# STAVILLEY MI, SHARRILLE

October 24, 1984

About 13 years ago I did a survey for Norman Hughes in the  $SW_{4}^{1}$  of the  $NW_{4}^{1}$  of Section 9, Township 16 North, Range 2 West.

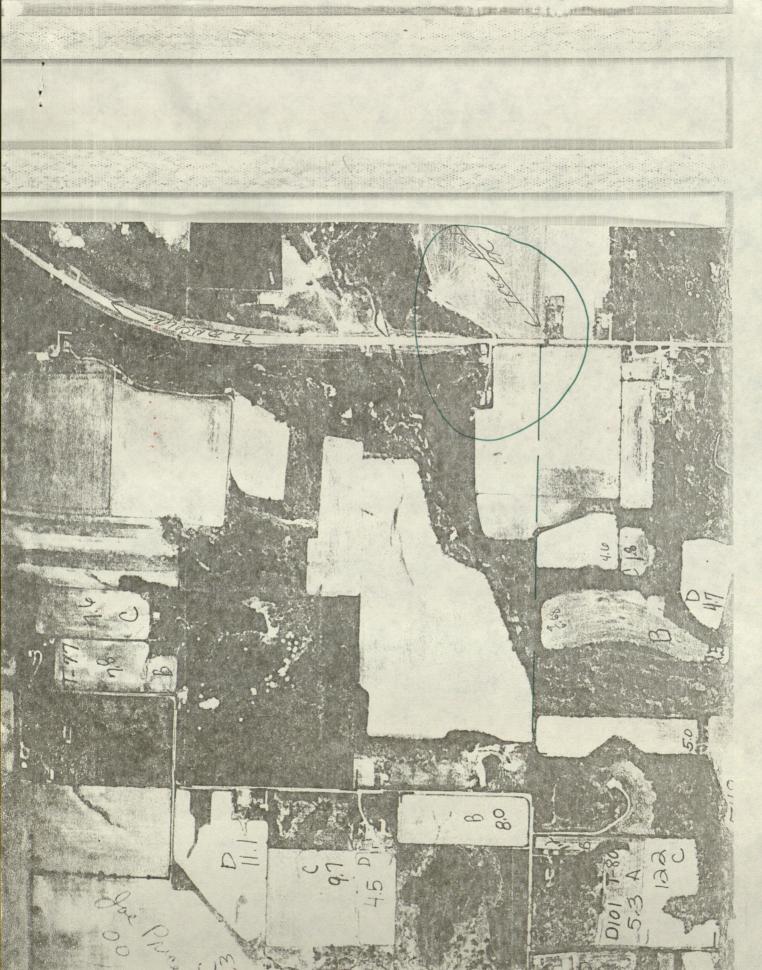
However, in looking at the aerial maps in the ASC office, it would weem that the quarter section line may be south of the tree and post you have used. In the transfer of the acreage south of the tree, 565.65 feet is the distance mentioned along the road from the south fence. Using a 100' tape by myself, I found there to be about 581', again showing possibility of error.

THIS IS NOT A GOOD COPY, BUT ON THE

BIG ASC MAP, THE COUNTY ROAD TO

THE WEST, MY SOUTH LINE ON THE WEST

END OF THE FARM, AND THE FENCE ON

THE EAST SIDE OF STRD 75 ACC SEEM

TO BE IN LINE.

THE FENCE TAKEN OUT SONTH OF THE OLD END POST WAS NOT IN LINE WITH THE SOUTH LINE ON BACK. I HAVE NO WAY OF KNOWING HOW FAR OFF IT WAS BECAUSE THE SOUTH PART WAS DURERDLY BECAUSE THE SOUTH PART WAS DURERDLY BONE. ARCHITECT - ENGINEER - LAND SURVEYOR - REALTOR

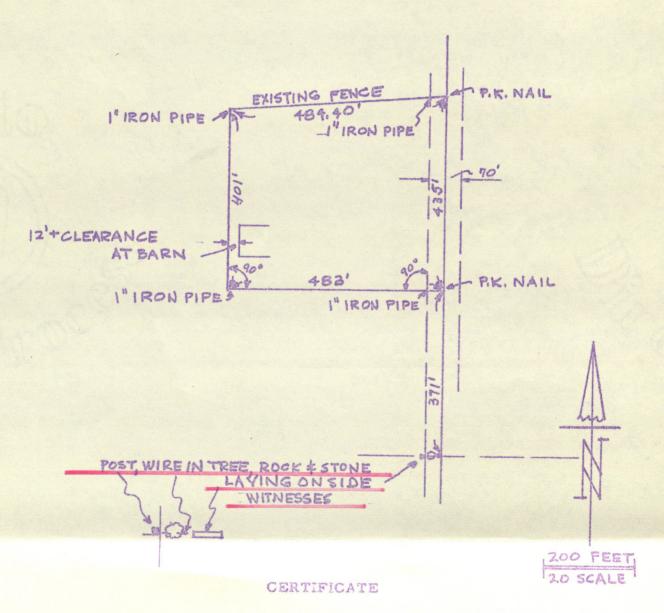
They have discovered an error in the description on your survey of February 27, 1971. It has to do with the location of the quarter section line. They find it to be off by some 14 feet, which would be very serious if not corrected.

I went to the site and rechecked all my work. I found a place in the road where someone had dug looking for a corner. I checked this point with my magnetic metal locater. I did not find anything of metal that I could accept as a corner. The fence on the east side of road is new, and the cement post is fairly new. HOWEVER, when you look at conditions on the west side of the road, there are several things that make me think that I am right. There is a tree with fence wire still in tree. There is a fence post with wire going WEST (indicating that the fence going west was the line). There is a large rock also in line with the wire in the tree and on the fence post.

I tied red ribbons on the wires, the post and sprayed rock and center of road. The right-of-way is much wider on the west side of the road than on the right side of the road. Most roads are centered between the right-of-way. In this case the road is much further east that normal. In other words the road is probably not on the quarter-quarter section line. I also checked the measurements and my measurement is still the same. The measurement by someone else is as you said it is. Knowing Stanley Shartle as well as I do, and knowing how he established section corners I feel that he did not establish a section corner in the center of the paved road In This Case.

The difference of 14 feet can be accounted for in several ways. There might have been a gate on the east side of the road, and the post was one of the gate posts. However I did not find any hinge bolts in the fence post (concrete). I also did not find any wire in the fence post to indicate any line. The fence on the west by being much older is prior evidence of intent. Many new fences are being built off the line to avoid trees, and other obstacles.

I think that my survey is valid. I did much troubleshooting for the State Highway in 1962 thru 1969. I found many such discrepancies such as this. If and when you sell this property a new survey of the whold thing will have to be made and then a perimeter survey showing dimensions of the entire property will correct any error IF ANY.
